## 7.2 Reactor Protection (Trip) System (RPS)—Instrumentation and Controls

The information in this section of the reference ABWR DCD, including all subsections, tables and figures, is incorporated by reference with the following departures and supplements.

Figure 7.2-2 Reactor Protection System Equipment Arrangement (From Sensors Through Trip Actuators)

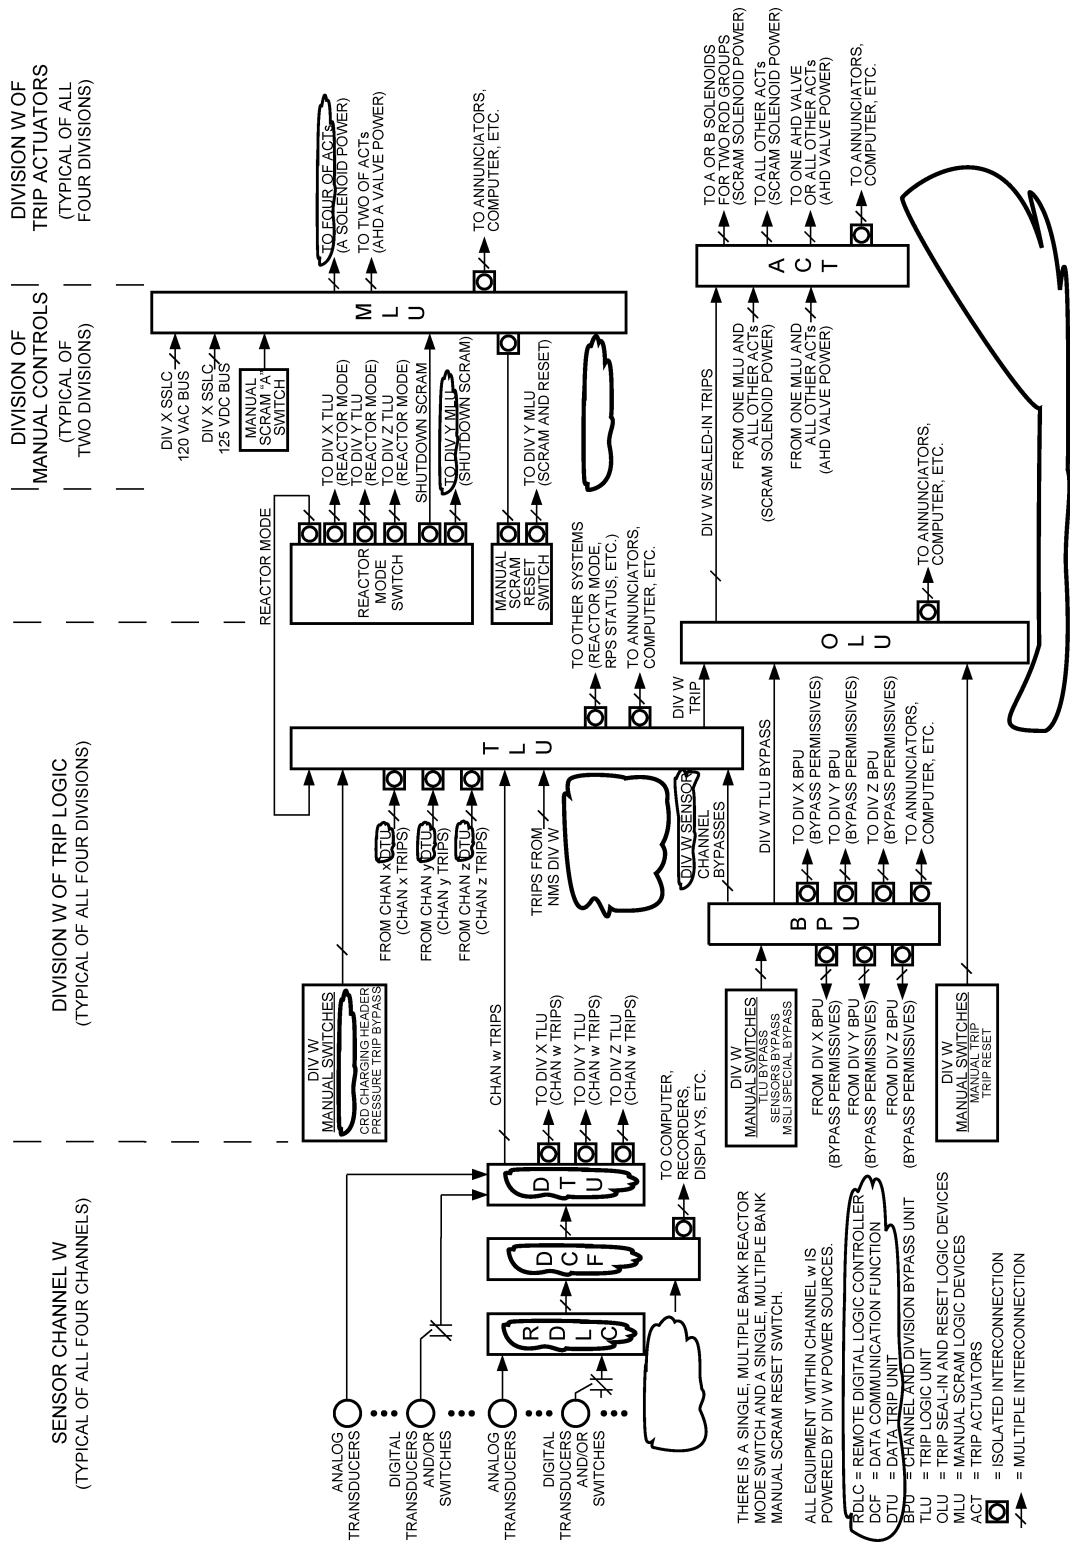
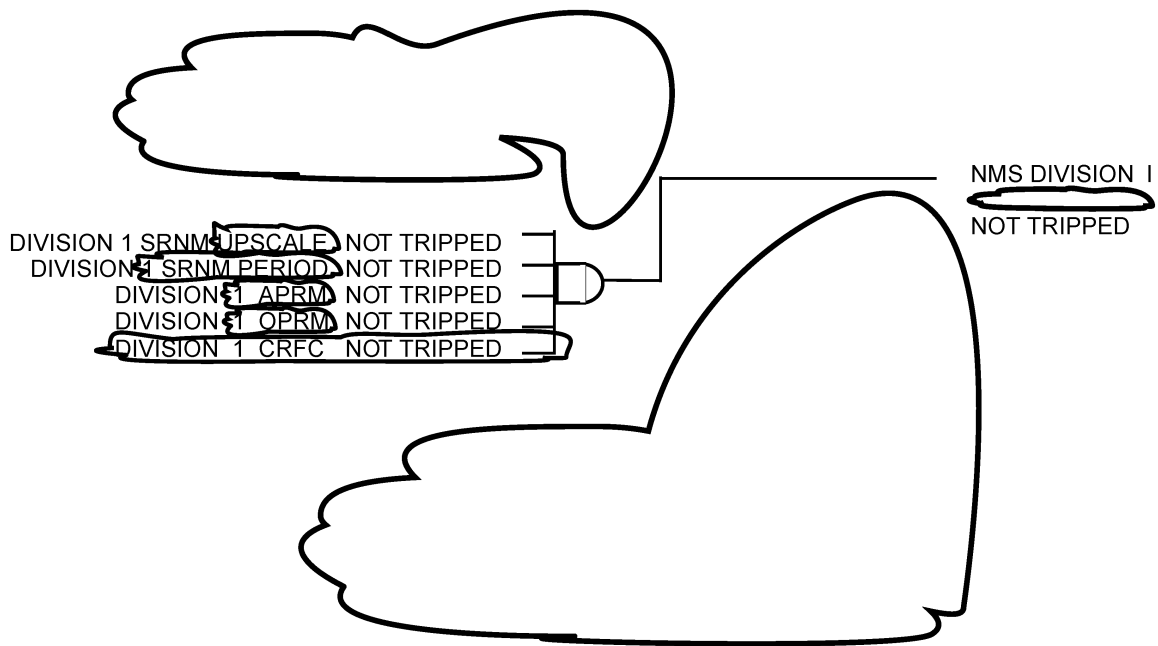
*The RPS equipment is divided into four redundant divisions of sensor (instrument) channels, trip logics and trip actuators, and two divisions of manual scram controls and scram logic circuitry. The sensor channels, divisions of trip logics, divisions of trip actuators and associated portions of the divisions of scram logic circuitry together constitute the RPS scram and air header dump (backup scram) automatic initiation logic. The divisions of manual scram controls and associated portions of the divisions of scram logic circuitry together constitute the RPS scram and air header dump manual initiation logic. The automatic and manual scram initiation logics are independent of each other. RPS equipment arrangement is shown in Figure 7.2-2.*

*Equipment within a sensor channel includes primarily sensors (transducers or switches), ~~multiplexers~~ data communication equipment and digital trip modules (DTMs) ~~trip units (DTUs)~~. The sensors within each channel monitor plant variables (Subsection 7.2.1.1.4.2) send either analog or discrete output to ~~remote multiplexer units (RMUs)~~ Remote Digital Logic Controllers (RDLCs) within the associated division of ~~Essential Multiplexing System (EMS)~~ data communication. Each division of the EMS data communication performs analog-to-digital conversion on analog signals and sends the digital or digitized analog output values of all monitored variables to the ~~DTM DTU~~ within the associated RPS sensor channel. The ~~DTM DTU~~ in each sensor channel compares individual monitored variable values with trip setpoint values and for each variable sends a separate, discrete (trip/no trip) output signal to all four divisions of trip logics.*

Four independent sensor channels monitor the various process variables listed in Subsection 7.2.1.1.4.2. The redundant sensor devices are separated so that no single failure can prevent a scram. The arrangement of RPS sensors mounted in local racks is shown in Figure 7.2-2. Locations for local RPS racks and panels are shown on the instrument location drawings provided in Section 1.7. Divisional separation is also applied to the ~~Essential Multiplexing System (EMS) Ddata Ecommunication~~ for RTIS, which provides data highways for the sensor input to the logic units. Physically separated cabinets are provided for the four scram logics. Fiber optic cable routing

Figure 7.2-5 Division 1 Trip Logic Coincident and Non-Coincident NMS Trips

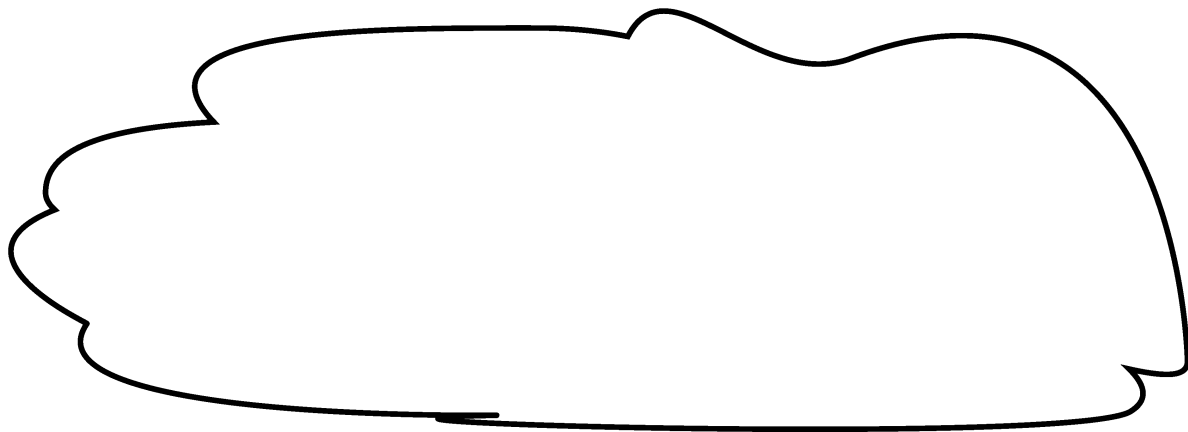
STD DEP 7.2-1 (Figure 7.2-5, 7.2-9, 7.2-10)

Each of the four divisions of the NMS equipment provides separate, isolated, ~~bistable~~ SRNM trip and APRM trip signals to ~~all four divisions~~ the corresponding division of RPS trip logics (Figure 7.2-5).

~~A coincident~~ An NMS trip will occur in each division of trip logic when ~~any two or more out of four divisions of~~ APRM or SRNM trip signals are received from the NMS. The ~~coincident~~ SRNM trip is automatically bypassed when the reactor is in the run mode. The coincident APRM trip cannot be bypassed.

~~A non-coincident NMS trip will occur in each division of trip logic when any single APRM or SRNM trip signal is received from the NMS. The non-coincident NMS trip is automatically bypassed when the reactor is in the run mode. When the reactor is in the shutdown, refuel or startup mode, the non-~~

~~coincident NMS trip can be manually bypassed in each division by a separate, manual, keylock non-coincident NMS trip disable switch.~~
